CITY OF NOVI CITY COUNCIL DECEMBER 2, 2024

SUBJECT: Initial review of the eligibility of Feldman Kia, JZ24-32, to rezone property at the southwest corner of Grand River Avenue and Joseph Drive from Non-Center Commercial to General Business with a Planned Rezoning Overlay.

PLANNING REVIEW

Rezoning Request from NCC (Non-Center Commercial District) to B-3 (General Business) with Planned Rezoning Overlay (PRO)

L-2

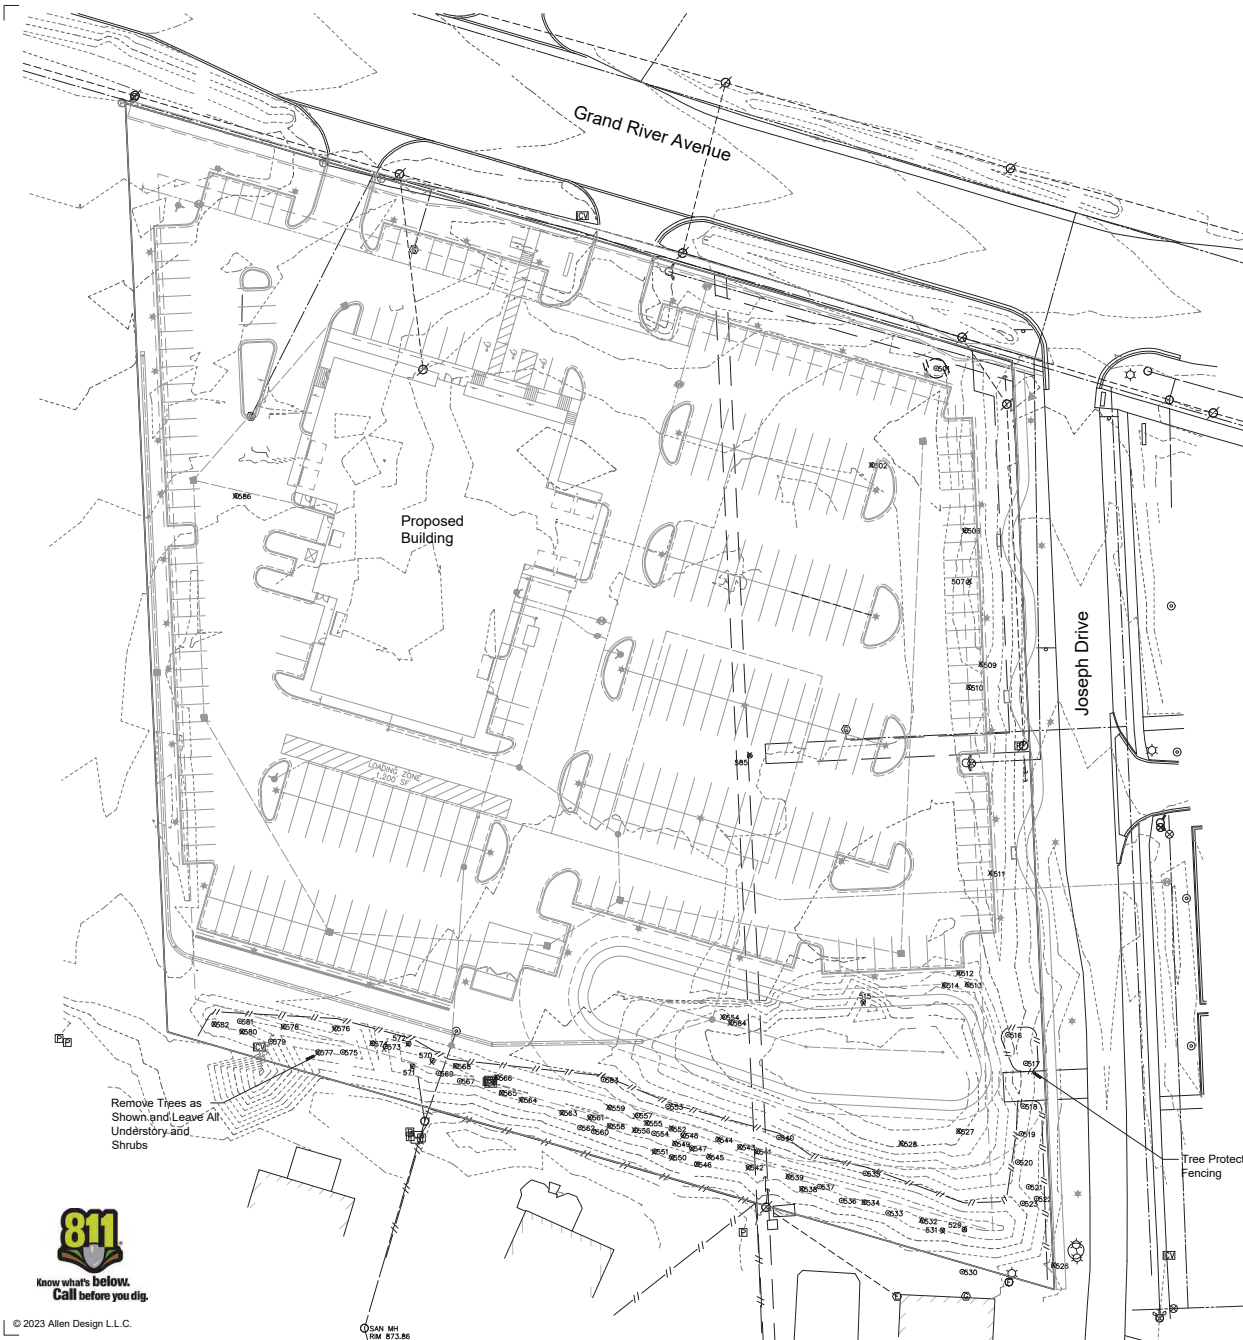
Staff Comment: As noted previously, there is conflicting information regarding the trees on the berm – Sheet 2 indicates they will "remain for screening" and sheets L-1 and L-2 state "Remove all trees as shown and leave all understory and shrubs." Staff is concerned that the proposed removal of existing trees (which are mostly in poor condition and covered in vines) without replanting on the berm does not offer a sufficient buffer to the adjacent residents to the south. If the trees are to be removed the height of the berm should be raised and new trees and/or fencing added on top of it to provide an adequate visual and aesthetic buffer to meet the ordinance requirements for 80% opacity in winter and 90% opacity in summer. This is particularly

Staff Comment from the September 12, 2024 Planning Review: As noted previously, there is conflicting information regarding the trees on the berm – Sheet 2 indicates they will “remain for screening” and sheets L-1 and L-2 state, “Remove all trees as shown and leave all understory and shrubs.” Staff is concerned that the proposed removal of existing trees (which are mostly in poor condition and covered in vines) without replanting on the berm does not offer a sufficient buffer to the adjacent residents to the south. If the trees are to be removed the height of the berm should be raised and new trees and/or fencing added on top of it to provide an adequate visual and aesthetic buffer to meet the ordinance for 80% opacity in winter and 90% opacity in summer. This is particularly important to help off-set the detriments of the auto dealership use at this location, so this deviation is not supported.

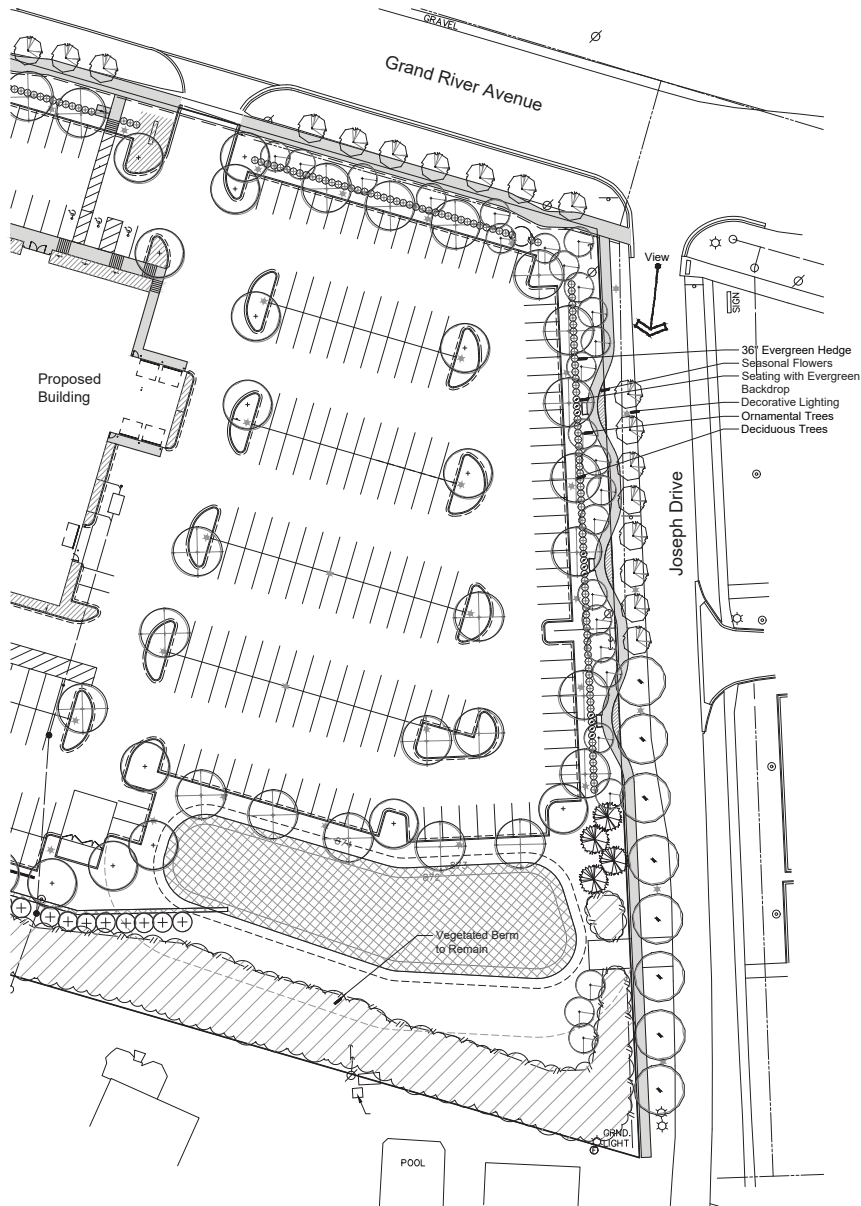
Staff Comment: Sheet L-4 of the PRO Plan shows a total of 3 benches to be provided at intervals along the sidewalk and includes a detail of the proposed

Staff Comment: Sheet L-4 of the PRO Plan shows a total of 3 benches to be provided at intervals along the sidewalk, and includes a detail of the proposed benches and decorative lighting fixtures. The benches and decorative lighting can be considered an enhancement. Providing a sidewalk on the Joseph Drive frontage is a requirement, so the meandering nature of it is the only unique feature, which may or not be considered an “enhancement.” As for the landscaping, the only element that exceeds what is required by the ordinance

SP1.3

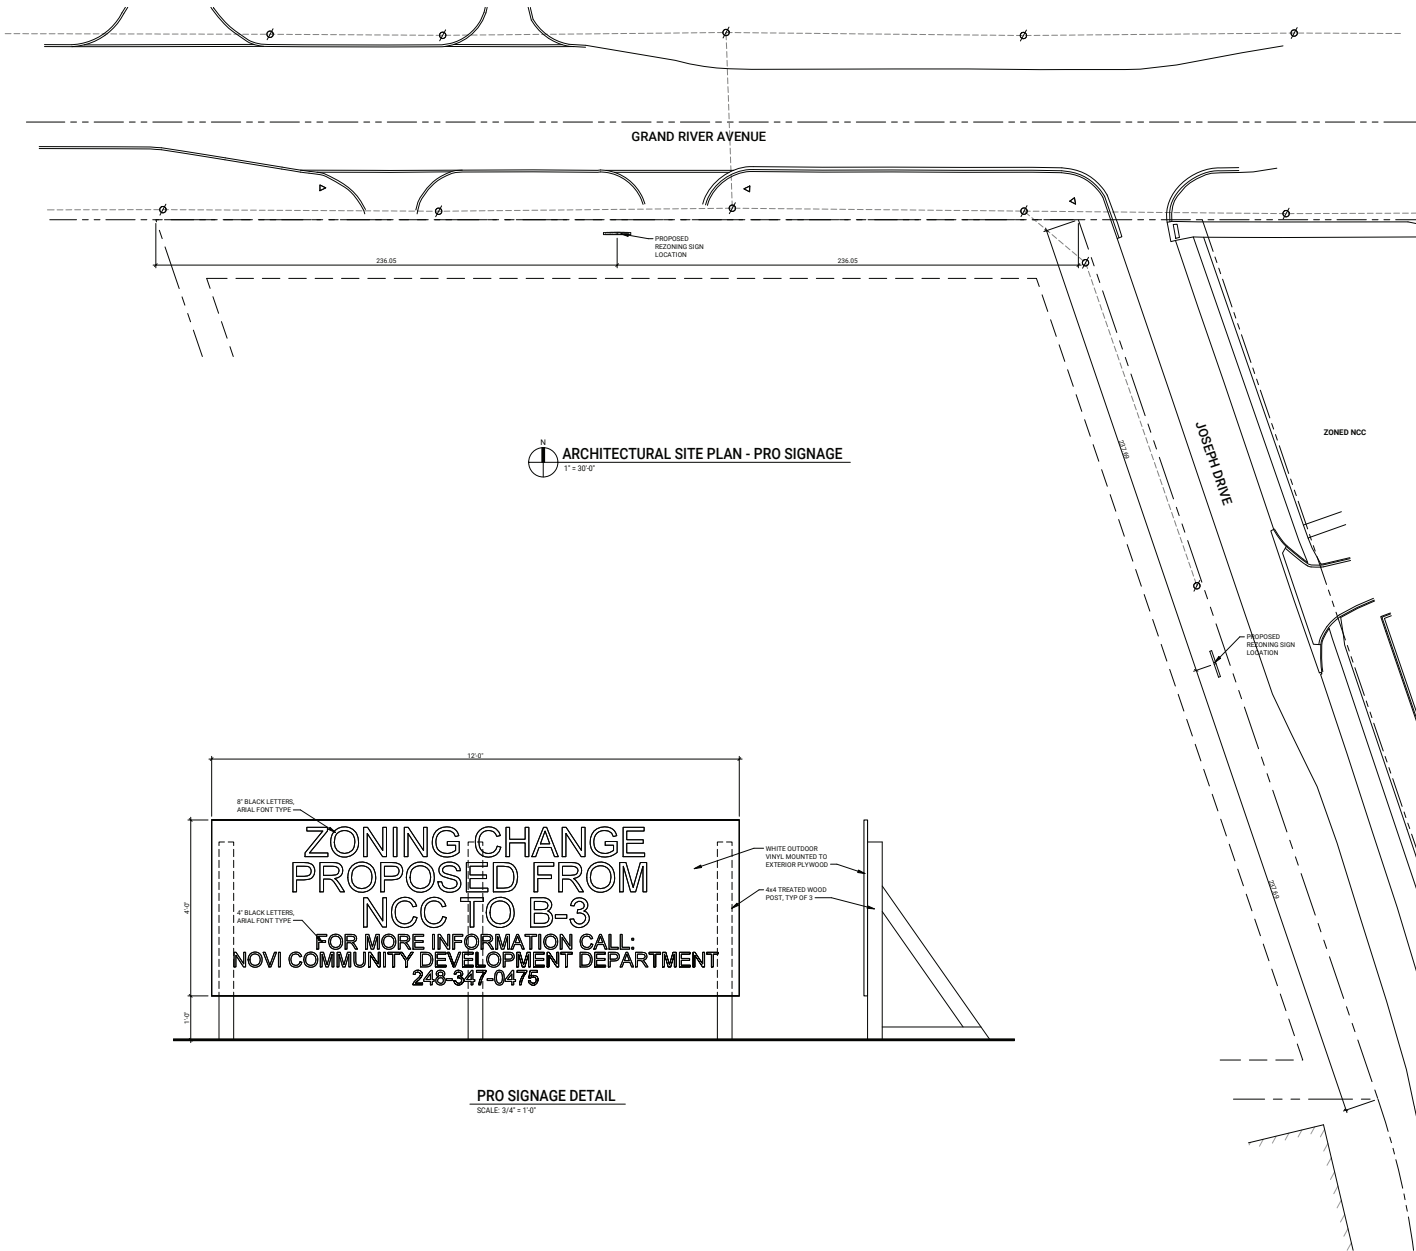
- d. Sign Location Plan: **A rezoning sign location plan and sign detail has been provided on Sheet SP1.3. The sign locations and wording are acceptable.**

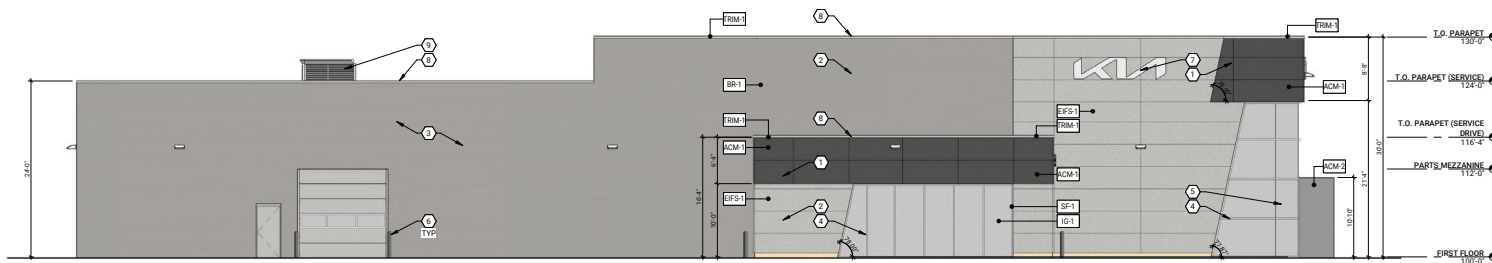
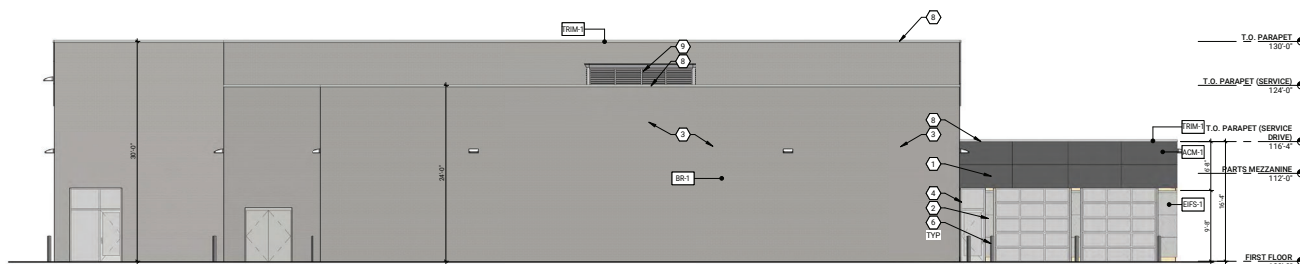
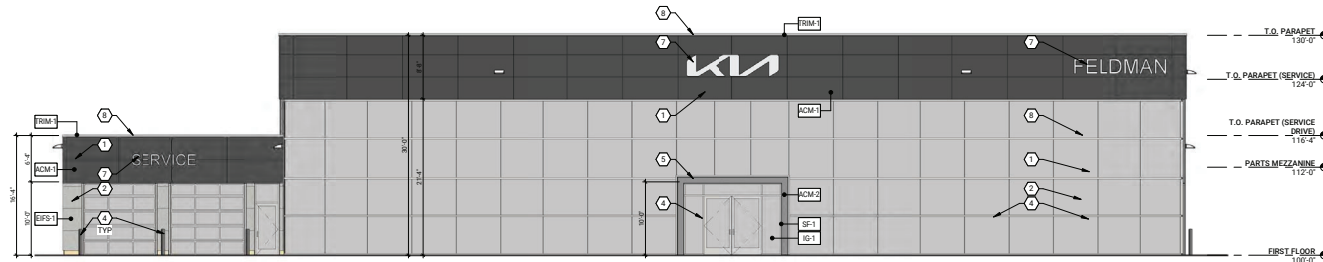
Staff Comment: As noted in the Façade Review, the front façade consists primarily of showroom glass, which is not regulated by the façade ordinance. "In this case the addition of Brick would not enhance the front façade, and all other facades have large percentages of brick. For this reason, we recommend that the design is consistent with the intent and purpose of the Façade Ordinance and that a Section 9 Façade Waiver be granted for the underage of Brick on the front facade."

The applicant is proposing 3 wall signs on the north elevation, which is 144 feet from the Grand River centerline ("KIA" 13'x3' = 39 sf, "Feldman" 13'x2' = 26 sf, "Service" = 9'x1.5' = 13.5 sf) with a total area of 78.5 square feet. One sign is proposed on the east elevation ("KIA" 13'x3' = 39 sf). One ground mounted sign, located 60 feet from the street centerline, is shown as 5 feet tall with a total area of about 40 square feet. **The applicant should clarify if these estimated dimensions are correct and provide additional information to be able to evaluate the deviations from the requirements of the sign code: ground sign distance from the centerline of Grand River, and the total area of each sign proposed (box placed around the entire sign area as shown to the right). A Sign Permit Application will be required for each sign proposed.**
